Attachment H
Exceptions to Design Standards (DRAFT)

Fact Sheet Exceptions to Caltrans Design Standards

Project Type:	<i>Roadway Widening</i>		
Proposed Facility:	<i>Freeway</i>		
County:	Placer	Route:	SR 65
Begin PM:	6.2	End PM:	12.8
Design Vehicle:	(TA) STAA	Design Period:	20 Years

"B1" LINE SUPERELEVATION DIAGRAM

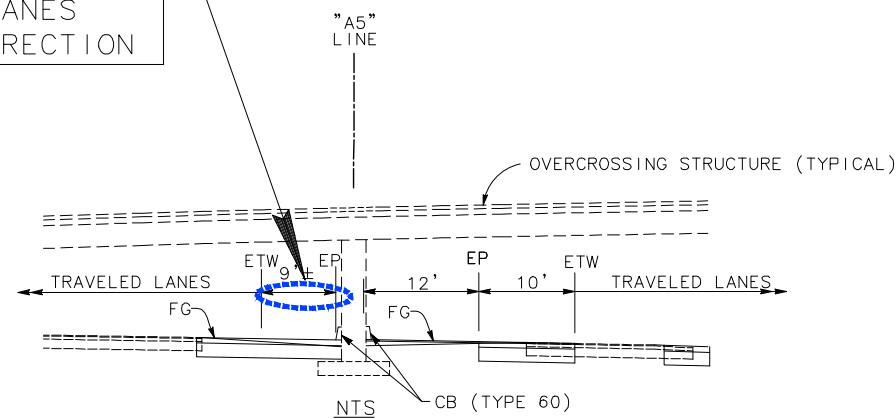
The proposed Blue Oaks Boulevard NB loop on-ramp ("B1" Line) with curve C24 radius of 159 ft has a non-standard superelevation rate of 10% instead of 12%. See Attachment C for exhibits.

INDEX 202.2(1)
 STANDARD: 12% FOR RADIUS UNDER 625'
 PROPOSED: 10% FOR NB LOOP ON-RAMP

**ROUTE 65 AT
 PLEASANT GROVE BLVD. OC STATION 218+50 TO 219+50
 BLUE OAKS BLVD. OC AT STATION 269+30 TO 270+30
 BLUE OAKS BLVD OFF-RAMP OC AT STATION 273+90 TO 274+40**

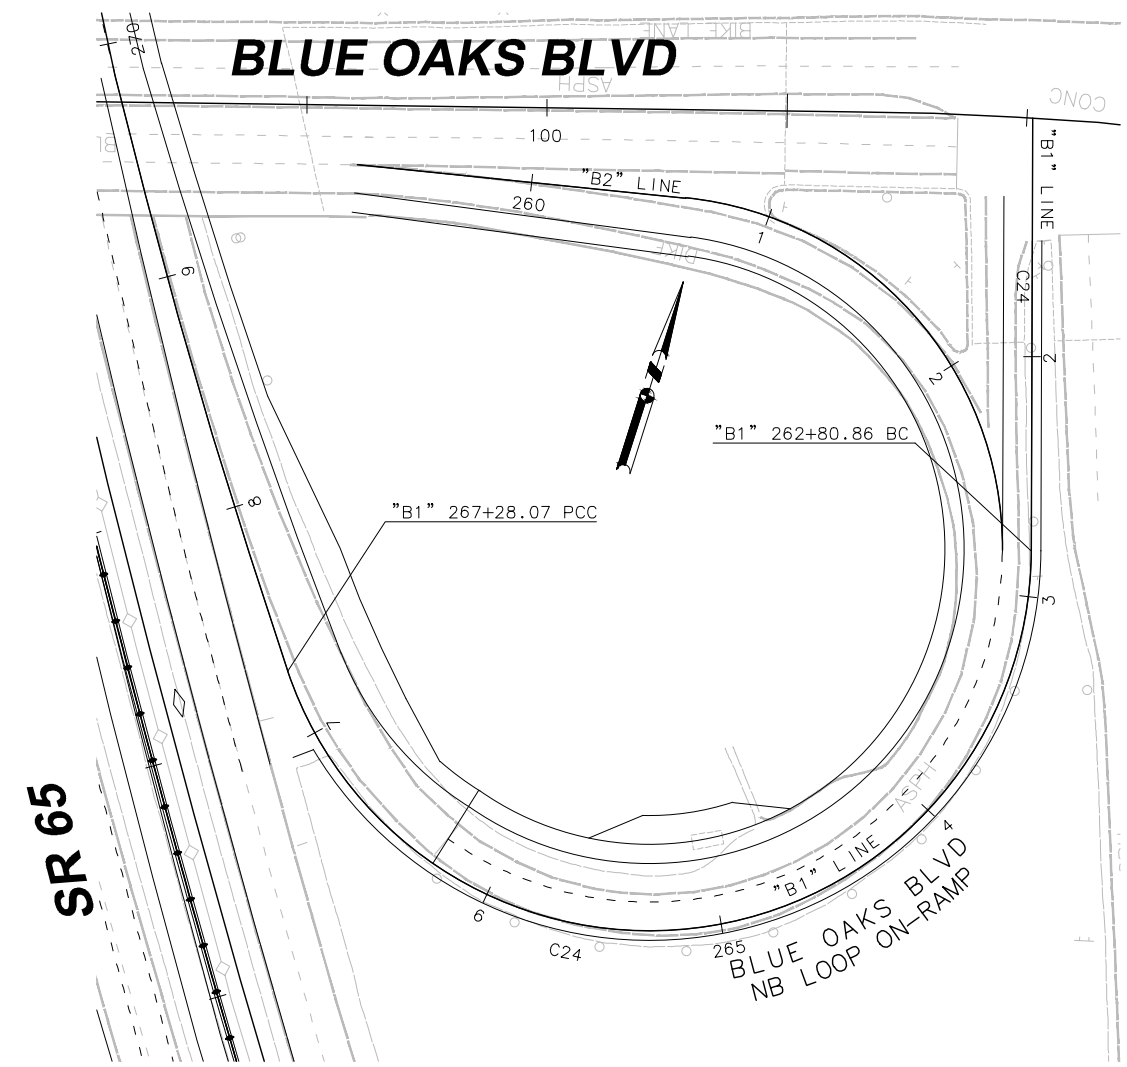
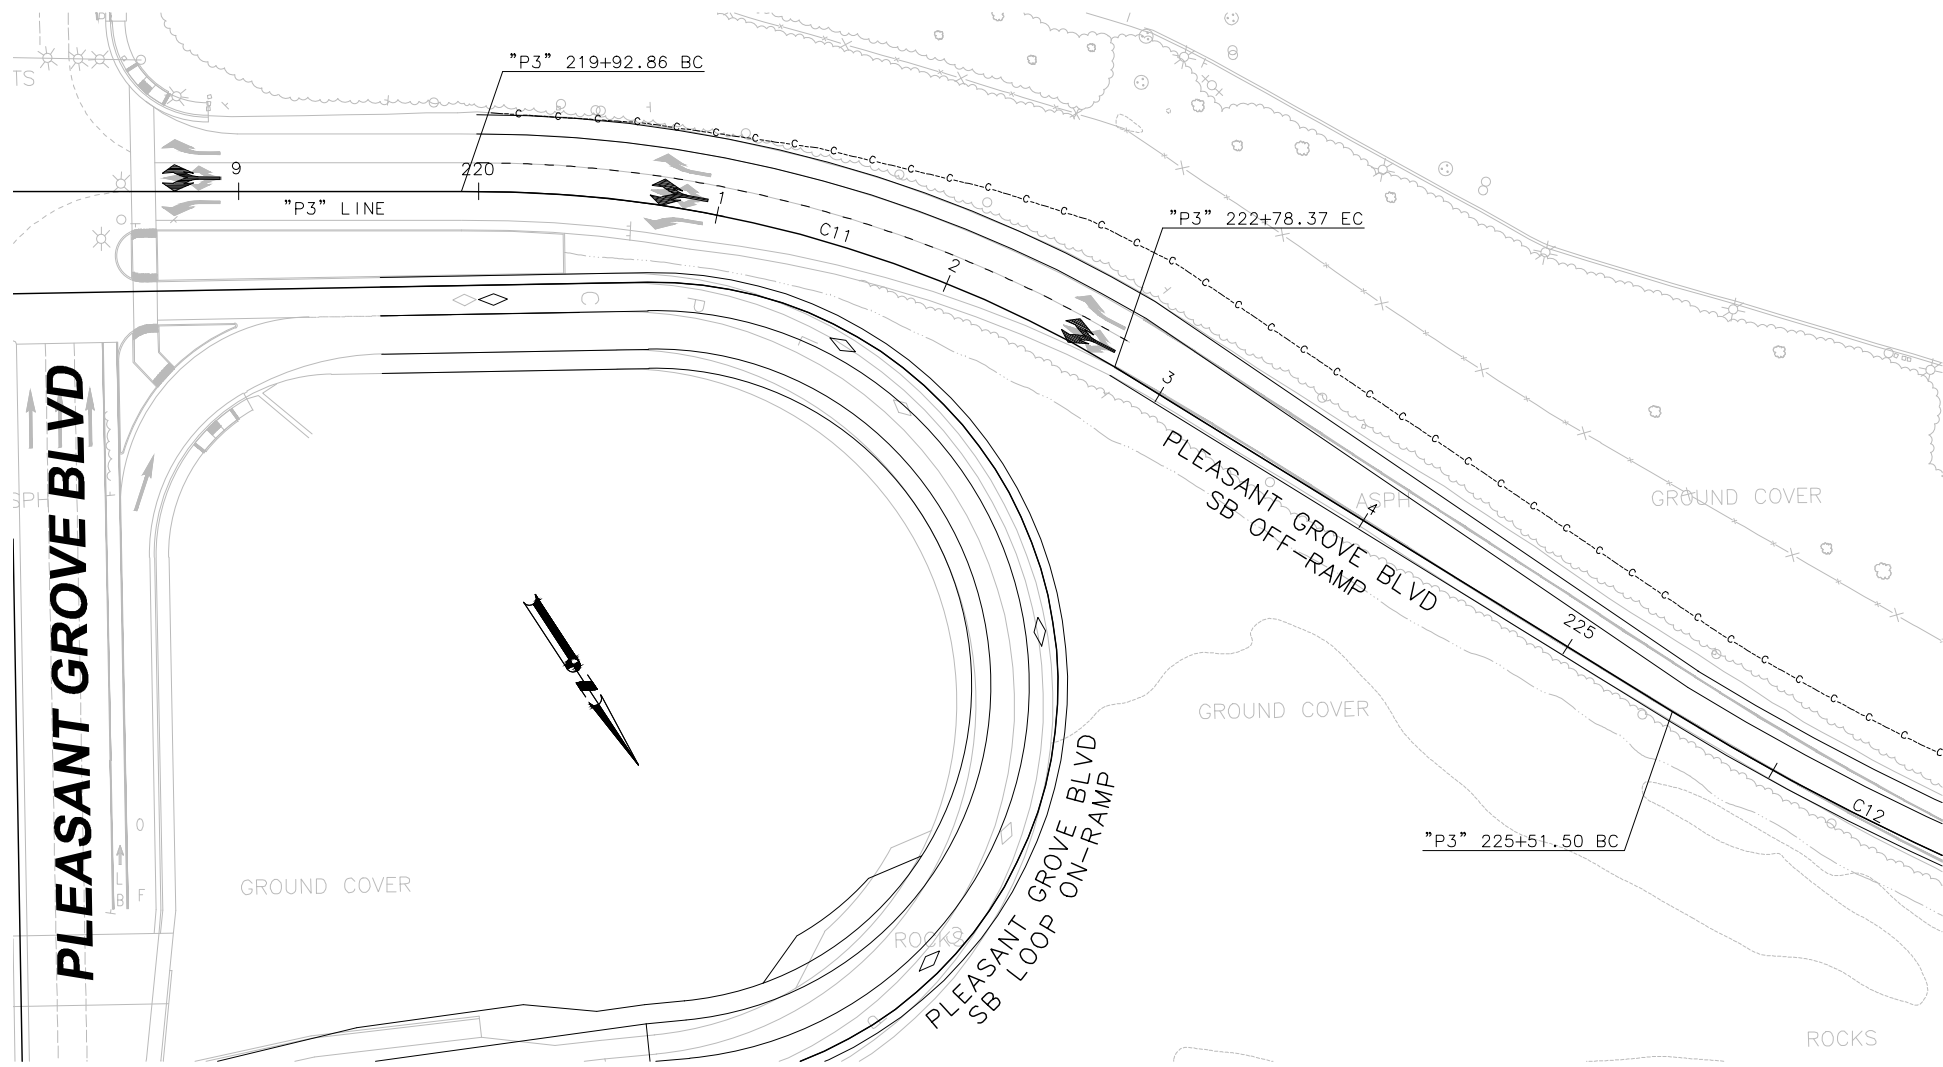
The following locations have proposed shoulder of less than 10 feet where proposed concrete barrier type 60 will be placed to protect the existing columns at the overcrossing structures:

For southbound SR 65 at Pleasant Grove Boulevard. from station 218+50 to 219+50, Blue Oaks Boulevard. from station 269+30 to 270+30 and Blue Oaks Boulevard. off-ramp from station 273+90 to 274+40, the inside shoulder width would be less than 10 feet next to a concrete barrier at the column, it will be a short transition before it goes back to standard width of 10 feet.

INDEX 302.1
 STANDARD: 10' FOR 6 OR MORE LANES
 PROPOSED: 9±' FOR SR 65 SB DIRECTION

"P3" LINE SUPERELEVATION DIAGRAM

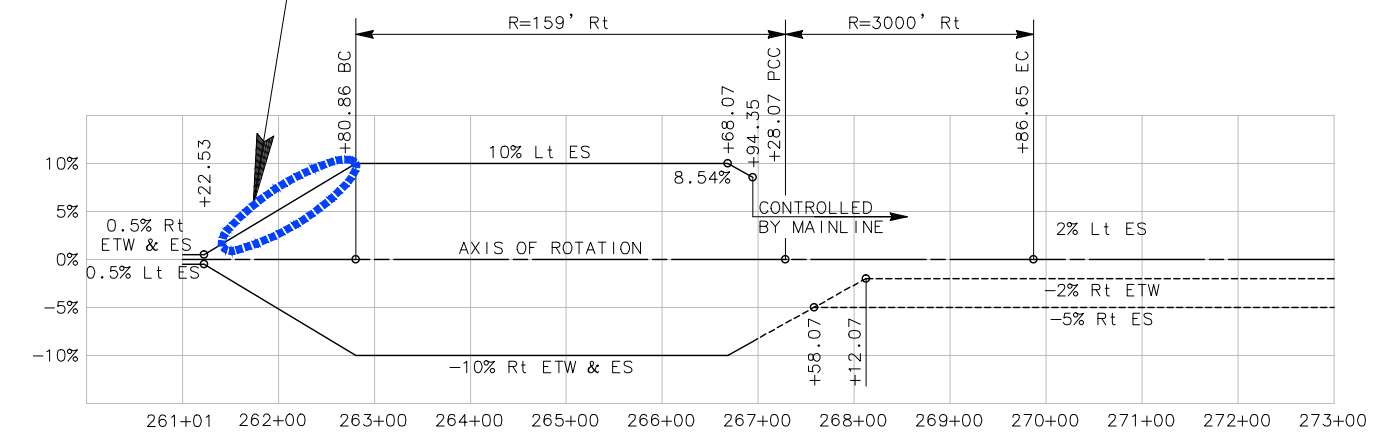
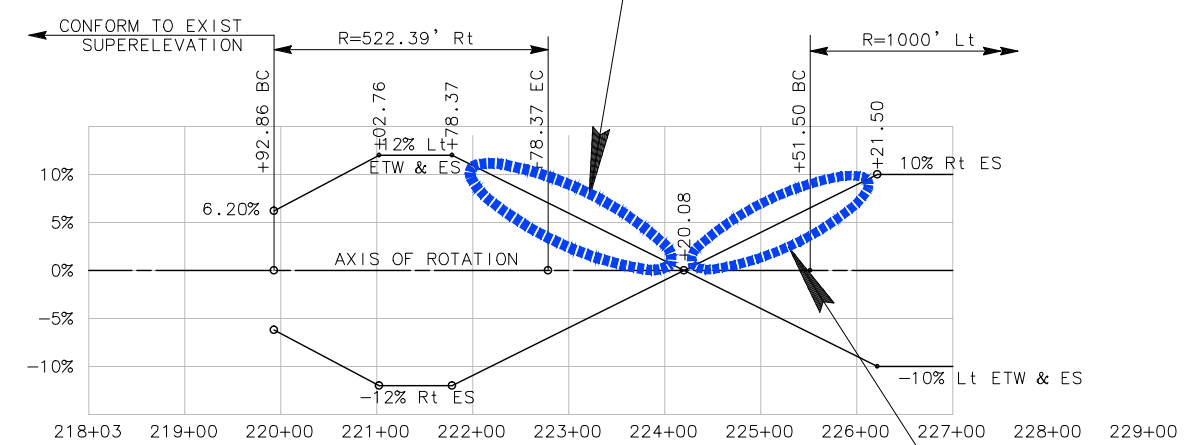
The alignment of SR65 SB off-ramp at Pleasant Grove Boulevard "P3" starts the superelevation at 12% superelevation for curve C11 and transition into 10% superelevation of curve C12 with n non-standard runoff lengths of 223 ft and 186 ft.

Similarly, for the southbound off-ramp (“P3”), the non-standard superelevation transition is located along the existing tangent section, between the curves C11 and C12, near the ramp terminal exit and is needed to conform to the roadway profile of Pleasant Grove Boulevard. Vehicle speeds are expected to be low (35 mph or less) in this area.

SUPERELEVATION TRANSITION
 INDEX 202.5
 STANDARD: 300 FEET FOR 12%
 PROPOSED: 223 FEET

SUPERELEVATION TRANSITION
 INDEX 202.5
 STANDARD: 210 FEET FOR 10%
 PROPOSED: 186 FEET

"B1" LINE SUPERELEVATION DIAGRAM

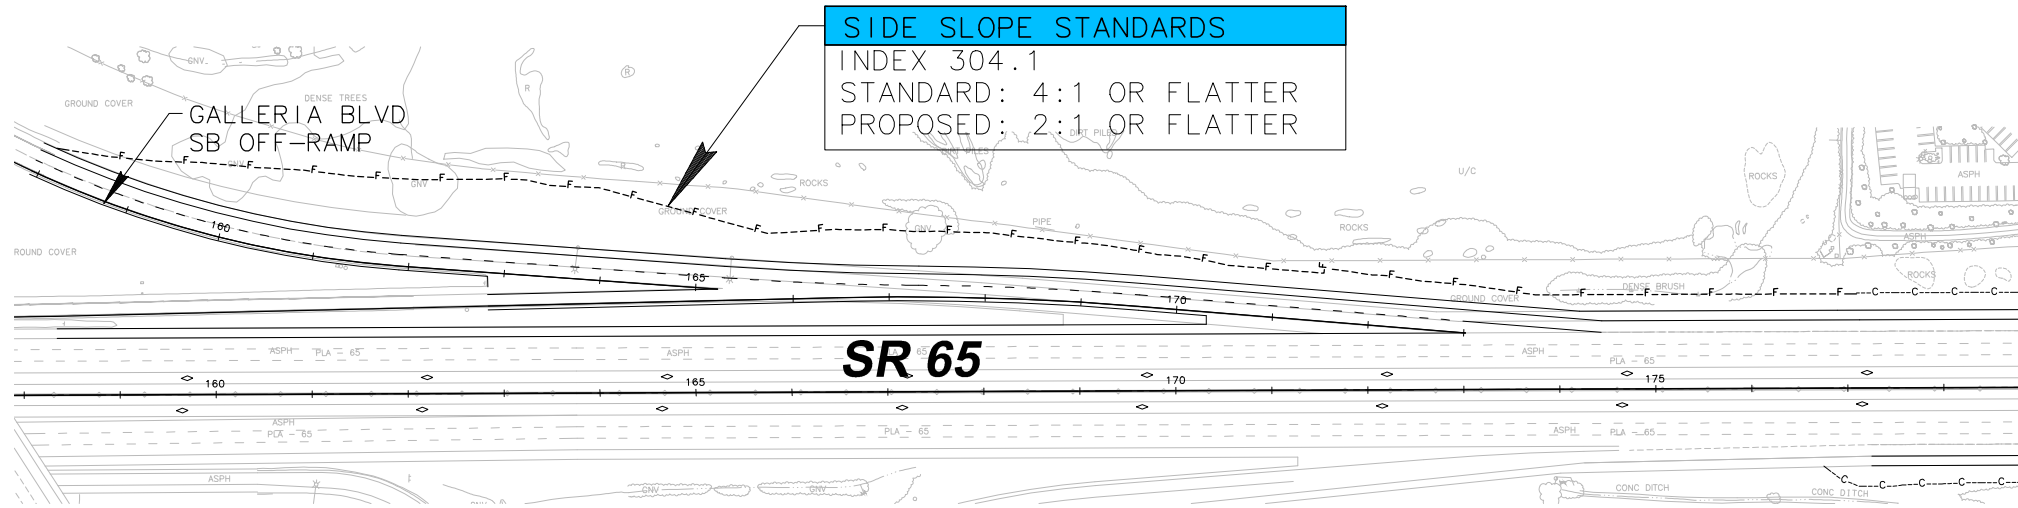
The alignment of SR65 NB loop on-ramp from EB Blue Oaks Boulevard "B1" starts the superelevation at 0.5% to match overcrossing profile and transition into 10% cross slope in a non-standard runoff length of 167 ft.

The proposed project includes retrofitting the existing NB loop on-ramp for ramp metering as a result of the VA Study. The ramp needs to be realigned to accommodate an added mixed flow lane while holding the existing configuration at the ramp intersection and at the gore area. The non-standard superelevation transition is located along the tangent section at the ramp entrance conforming to the Blue Oaks Boulevard roadway profile. Vehicle speeds are expected to be low (30 mph or less) in this area.

SUPERELEVATION TRANSITION
 INDEX 202.5
 STANDARD: 240 FEET FOR 10%
 PROPOSED: 170 FEET

LOCATION 1: GALLERIA SB OFF-RAMP 164+00 TO 171+50

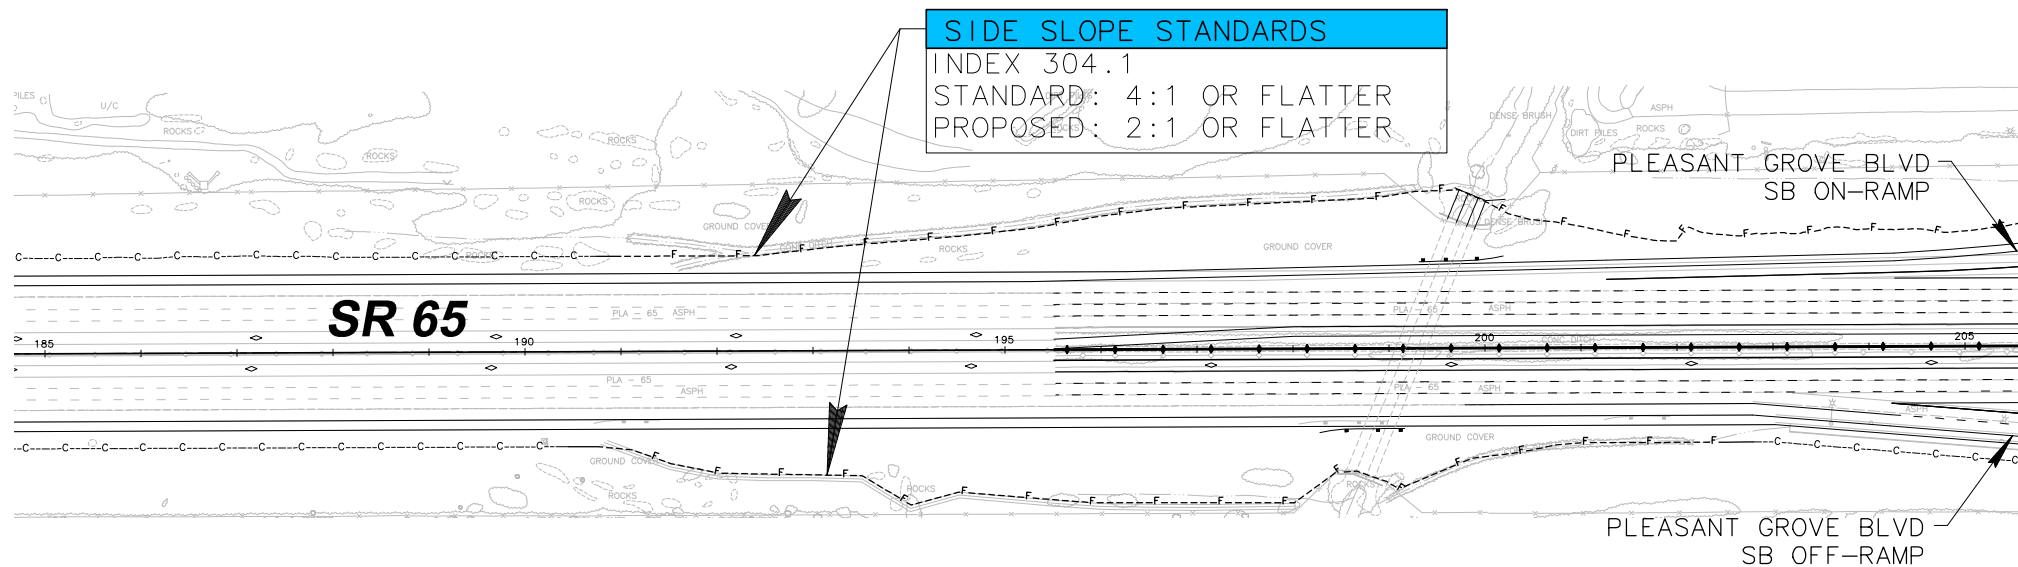
The following locations have proposed embankment slopes steeper than 4:1 (H:V):

- Galleria Boulevard SB Off-Ramp from Station 164+00 to 171+50 (750 LF)
- SR 65 SB direction from Station 191+00 to 202+00 (1100 LF)
- SR 65 NB direction from Station 191+00 to 200+00 (900 LF)
- SR 65 SB direction from Station 241+50 to 248+00 (650 LF)
